STATE OF CONNECTICUT  
CONNECTICUT SITING COUNCIL

CANDLEWOOD SOLAR LLC PETITION FOR : PETITION NO. 1312  
A DECLARATORY RULING THAT NO CERTIFICATE :  
OF ENVIRONMENTAL COMPATIBILITY AND :  
PUBLIC NEED IS REQUIRED FOR THE PROPOSED :  
CONSTRUCTION, MAINTENANCE AND :  
OPERATION OF A 20 MEGAWATT AC (26.5 :  
MEGAWATT DC) SOLAR PHOTOVOLTAIC :  
ELECTRIC GENERATING FACILITY LOCATED ON :  
A 163 ACRE PARCEL AT 197 CANDLEWOOD :  
MOUNTAIN ROAD AND ASSOCIATED ELECTRICAL :  
INTERCONNECTION TO EVERSOURCE ENERGY'S :  
ROCKY RIVER SUBSTATION ON KENT ROAD IN :  
NEW MILFORD, CONNECTICUT :  
August 28, 2017

**INTERROGATORY RESPONSES  
TO CONNECTICUT SITING COUNCIL  
SET ONE**

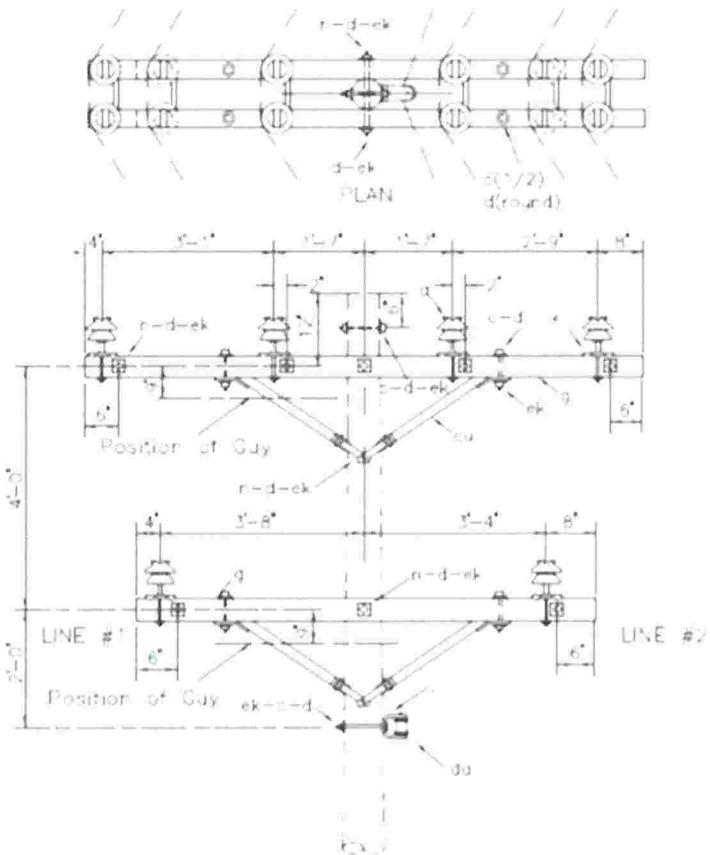
31. *Approximately how tall would the 13.8-kV distribution poles to be installed between the proposed project and RRSS be? Approximately how many poles would be installed? Would the 13.8-kV electrical connection run overhead to cross Route 7 (Kent Road) to reach RRSS, or would it be an underground connection "trenched" under Route 7 to reach RRSS? Provide a drawing or sample picture of one of the proposed distribution poles.*

Response: The overhead 13.8kV poles will range from 45-55 ft. tall depending on local topography variation. There are 37 overhead poles in the current design that runs from the solar array site to Rte. 7 adjacent to the RRSS. The proposed plan is to run the 13.8kV line above ground to Route 7, and then the line will run underground across Route 7 into the RRSS. However, this routing configuration will be confirmed with Eversource engineering studies. Below is an example of the RUS Double Circuit design overhead poles.

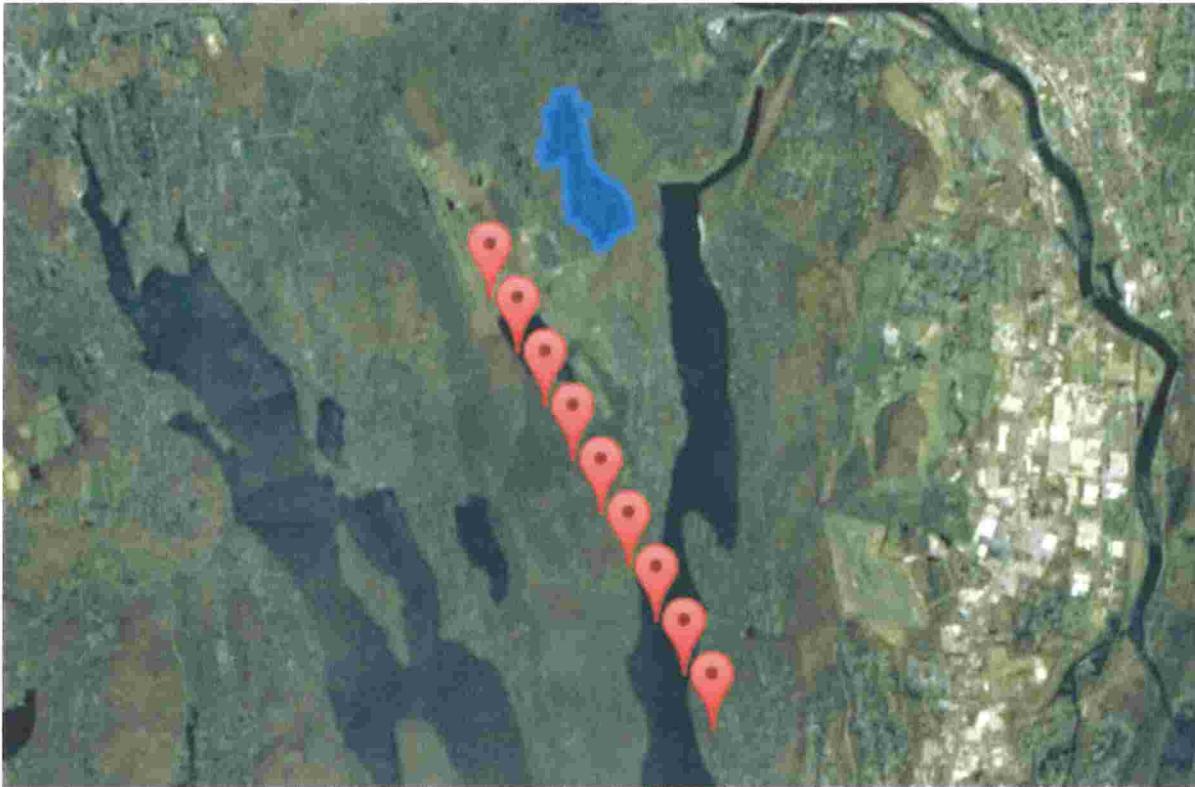
42. *Did the Petitioner conduct a Shade Study Analysis? Would shading present any challenges for the proposed project? Is most of the tree clearing to accommodate the project itself, or is some percentage of the tree clearing (e.g. to the south) associated with minimizing shading of the panels? Explain.*

Response: A detailed shading analysis using PV SYST and Helios 3D was done to consider all potential sources of shading. To minimize shading from trees, there are minimum setbacks from the tree lines that need to be used to the south, east and west. There is a relatively small percentage (less than 20%) of tree clearing that will be done to accomplish these setbacks and reducing shading so that we meet our contractual obligations under the PPAs.

Candlewood Lake Area Map

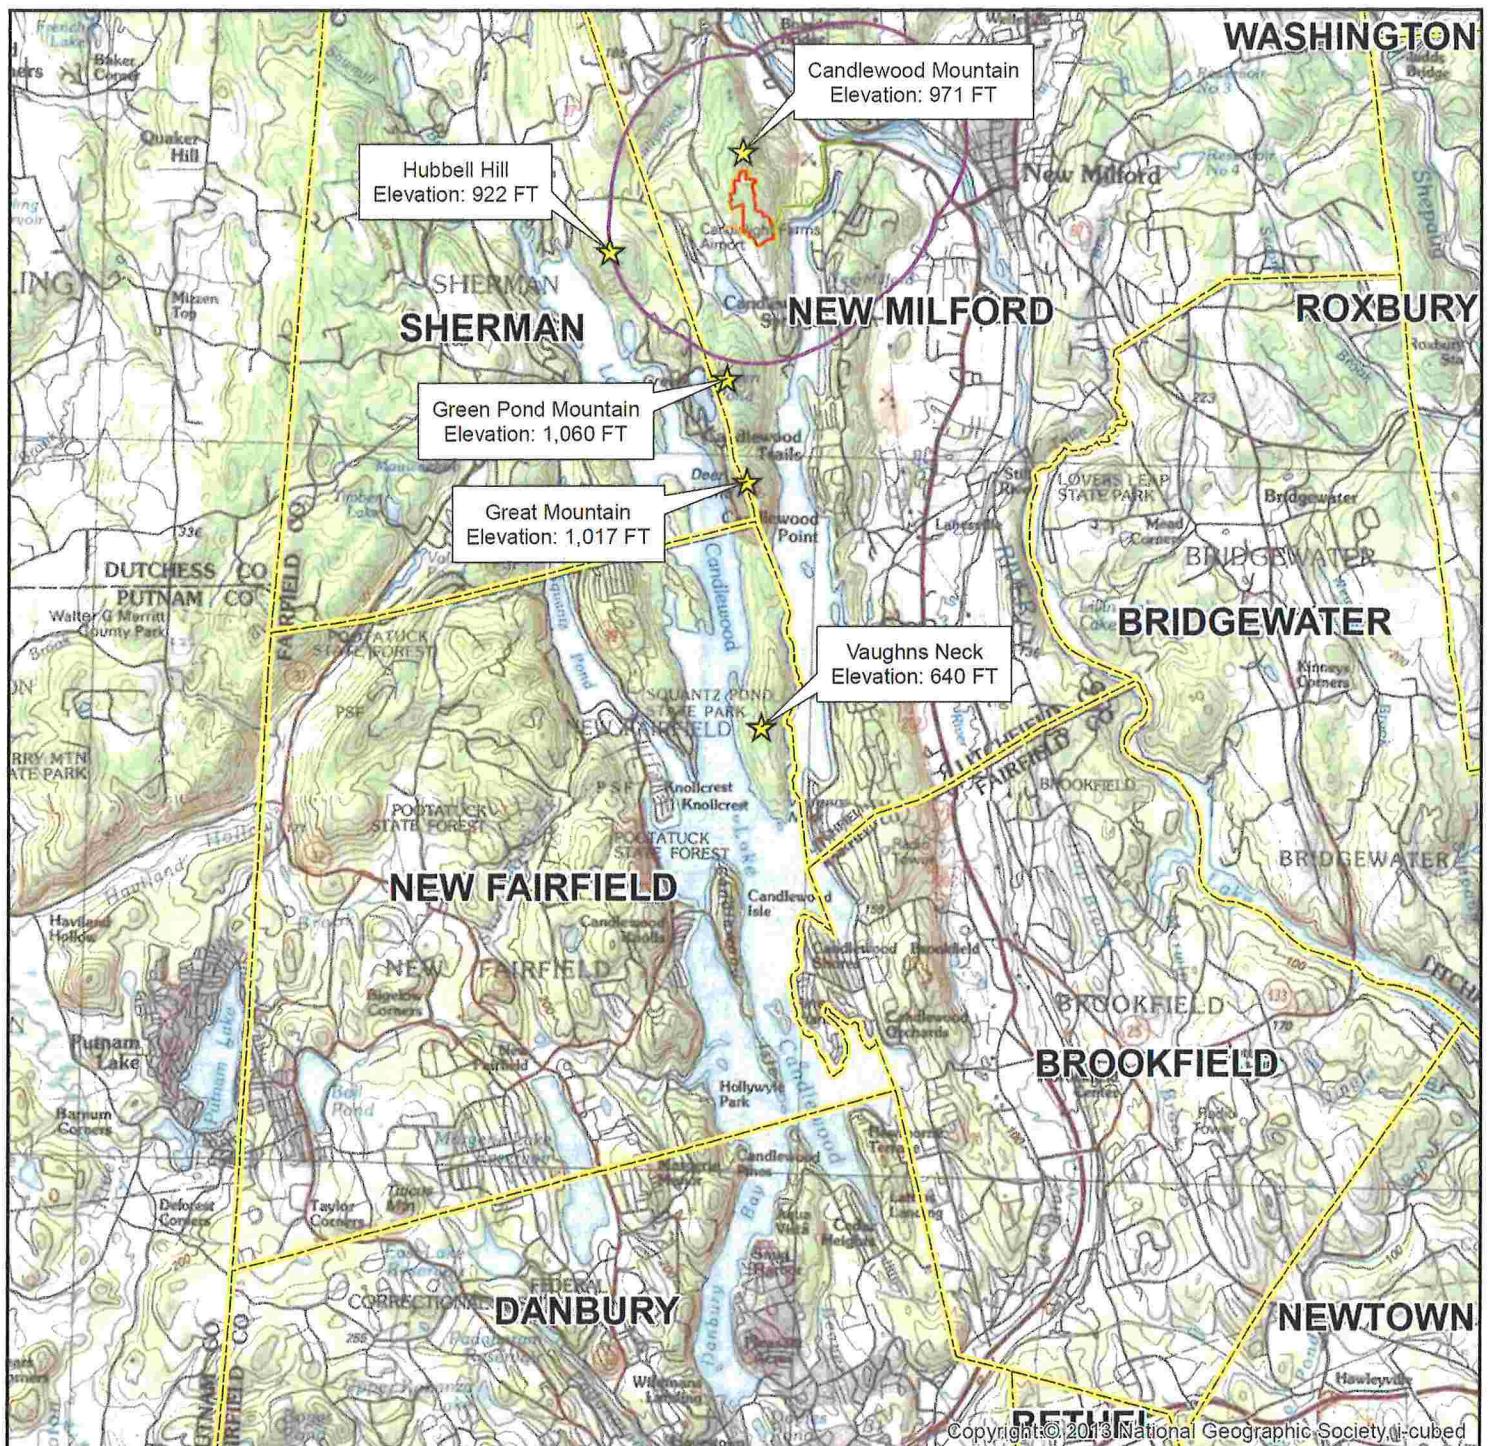
The nearest recreational area from the outer edge of the Solar Array is Candlewood Lake, approximately 730 feet to the east. Lynn Deming Park is located on the east side of Candlewood Lake, along the Lake's northeastern corner, and is approximately 1,350 feet from the approximate edge of the Solar Array. [Please see also response #13 for discussion on visibility]
